Silicon Anomaly List ADSP-BF542/BF544/BF547/BF548/BF549

ABOUT ADSP-BF542/BF544/BF547/BF548/BF549 SILICON ANOMALIES

These anomalies represent the currently known differences between revisions of the Blackfin® ADSP-BF542/BF544/BF547/BF548/BF549 product(s) and the functionality specified in the ADSP-BF542/BF544/BF547/BF548/BF549 data sheet(s) and the Hardware Reference book(s).

42. 05000457 - Host DMA Port Responds to Certain Bus Activity Without $\overline{\text{HOST_CE}}$ Assertion:

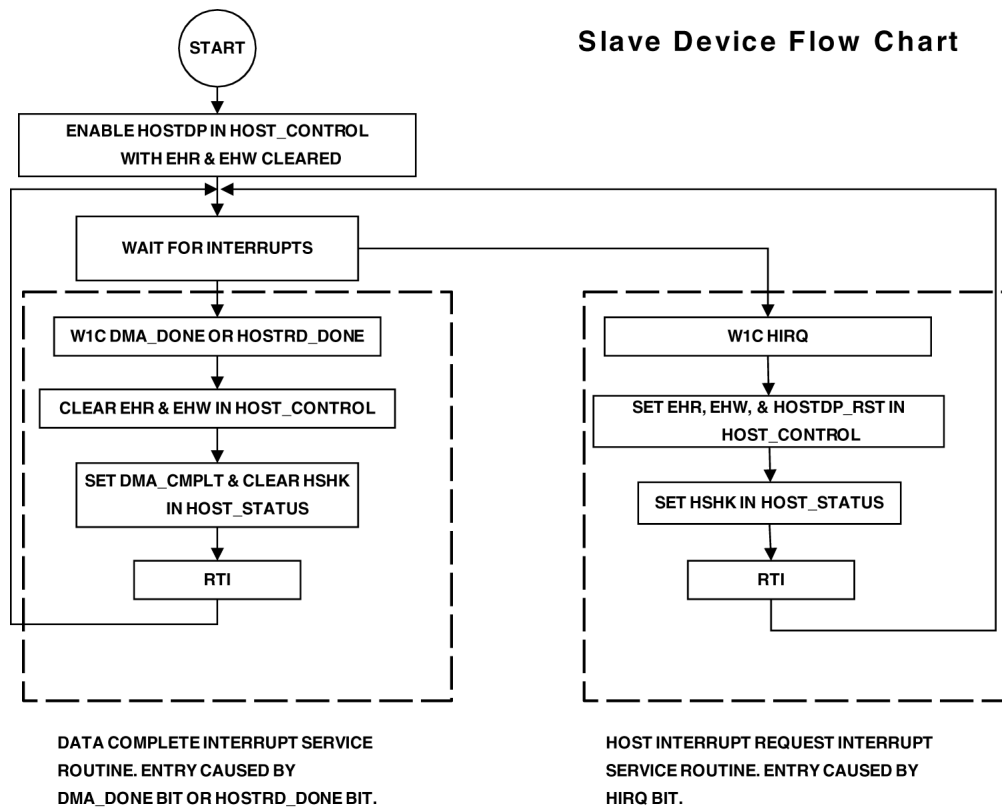
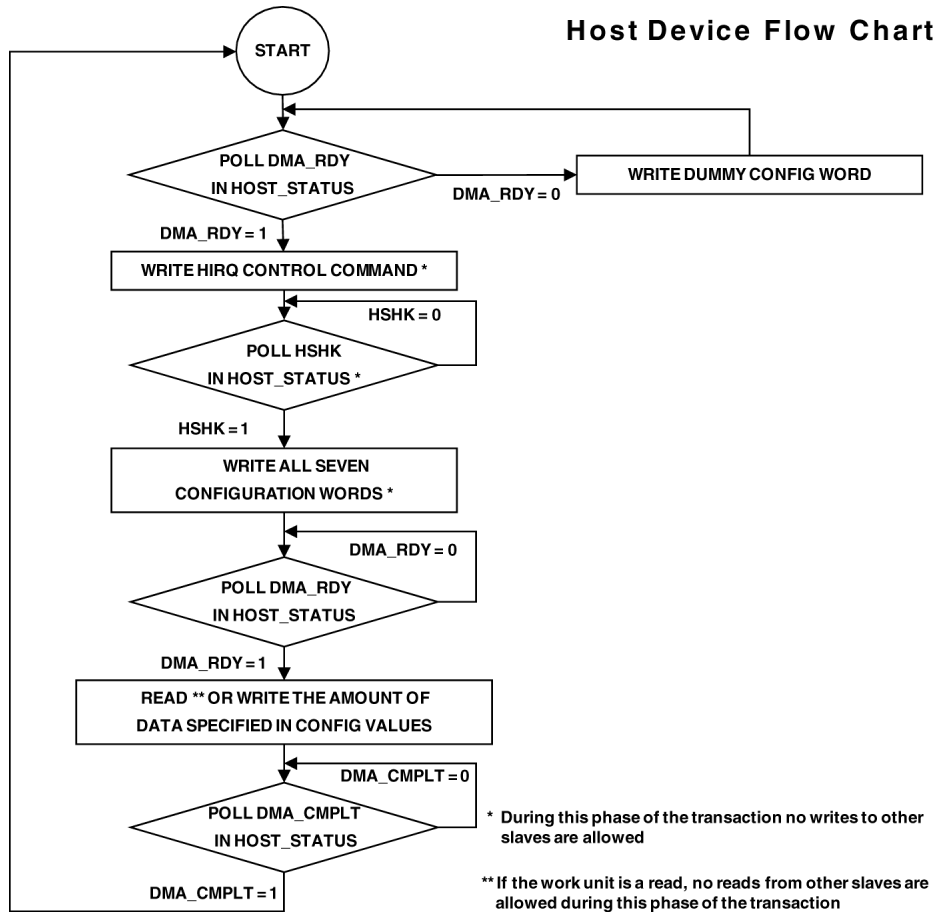
The Host DMA Port (HOSTDP) responds to certain bus activity even without the assertion of its chip enable, $\overline{\text{HOST_CE}}$. If the HOSTDP is the only slave on the bus (meaning that $\overline{\text{HOST_WR}}$ and $\overline{\text{HOST_RD}}$ are asserted by the host only for communicating with the HOSTDP), this anomaly will not be observed. There are two states in which the HOSTDP responds to bus activity (assertion of $\overline{\text{HOST_WR}}$ or $\overline{\text{HOST_RD}}$) without $\overline{\text{HOST_CE}}$ being asserted:

1. HOSTDP is Enabled and Waiting for the Host to Configure - While waiting for configuration in both acknowledge and interrupt modes, assertions of $\overline{\text{HOST_WR}}$ for other slaves can cause the HOSTDP to be erroneously configured.
2. HOSTDP is Configured for Data Reads - While waiting for data reads in both acknowledge and interrupt modes, assertions of $\overline{\text{HOST_RD}}$ for other slaves can cause the HOSTDP to subsequently return data out of order.

- a. Add additional logic - Connect to $\overline{\text{HOST_WR}}$ through a 2-input OR gate where one input of the OR gate is the host's write signal and the other is the host's chip select.
- b. Time bus accesses by the host processor - Do not write to other slaves on the bus between the time that the HOSTDP is enabled and the DMA_RDY bit in HOST_STATUS is set.
- c. Change the software on both the host and the slave as shown in the following flowcharts:

- a. Add additional logic - Connect to $\overline{\text{HOST_RD}}$ through a 2-input OR gate where one input of the OR gate is the host's read signal and the other is the host's chip select.
- b. Time bus accesses by the host processor - Do not read from other slaves on the bus between the time that the final configuration word (YMODIFY) is written to the HOSTDP and the DMA_CMLPT bit in HOST_STATUS is set.
